TECHNICAL SERVICE BULLETIN

10R140 Transmission - Ticking Or Scraping Noise Coming From Bellhousing

21-2100

01 April 2021

Figure 1

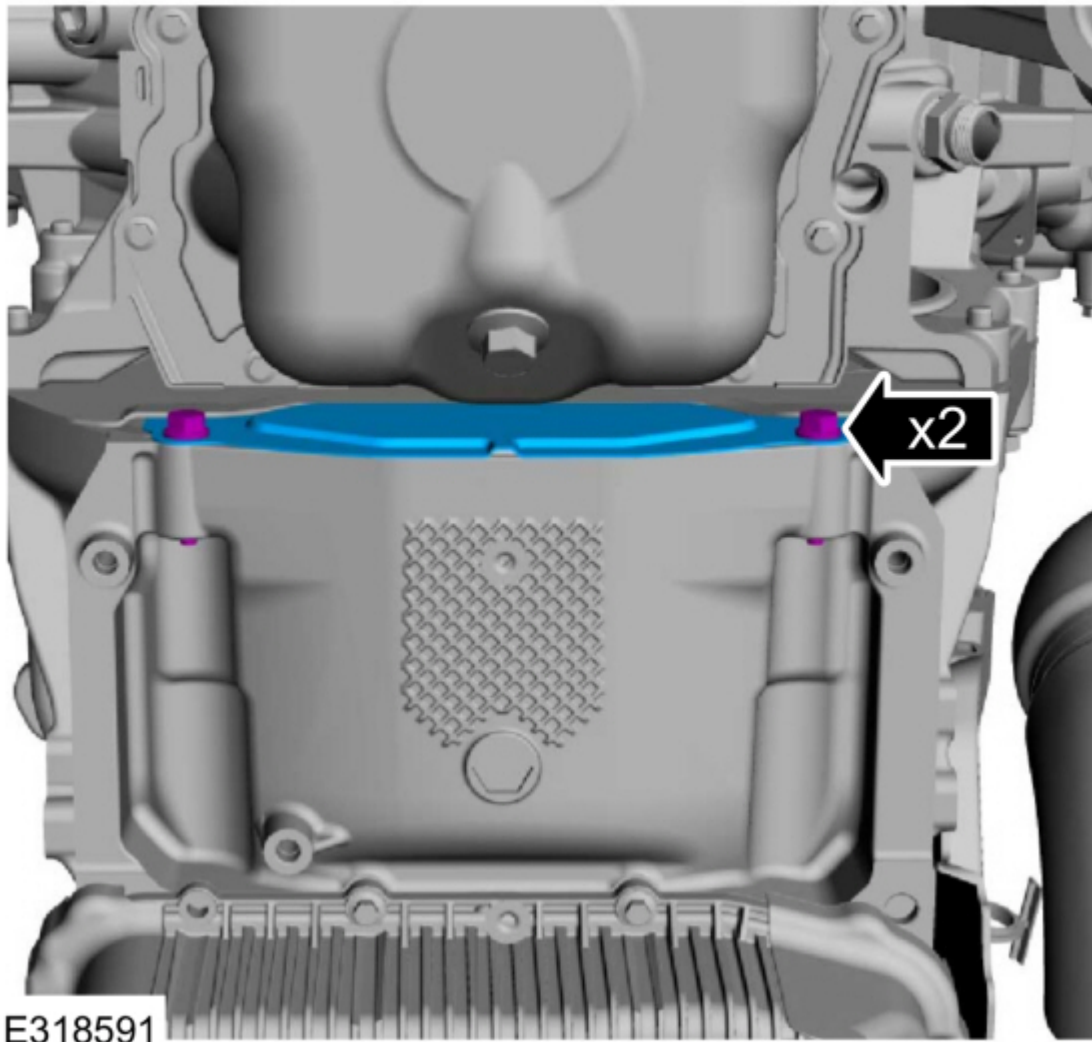
Issue: Some 2020-2021 F-Super Duty vehicles equipped with a 10R140 transmission may exhibit a ticking or scraping noise coming from the bellhousing. The noise may or may not go away while in PARK and/or NEUTRAL. This may be due to the torque converter studs contacting the flexplate inspection cover and/or internal torque converter damper spring contact. To correct the condition, inspect and adjust the flexplate inspection cover (gas engine only) and/or replace the torque converter (gas or diesel engine).

(1). Yes - remove and inspect the flexplate inspection cover for contact with the torque converter studs. If contact is found, adjust the cover so contact does not occur. Refer to Figure 1.
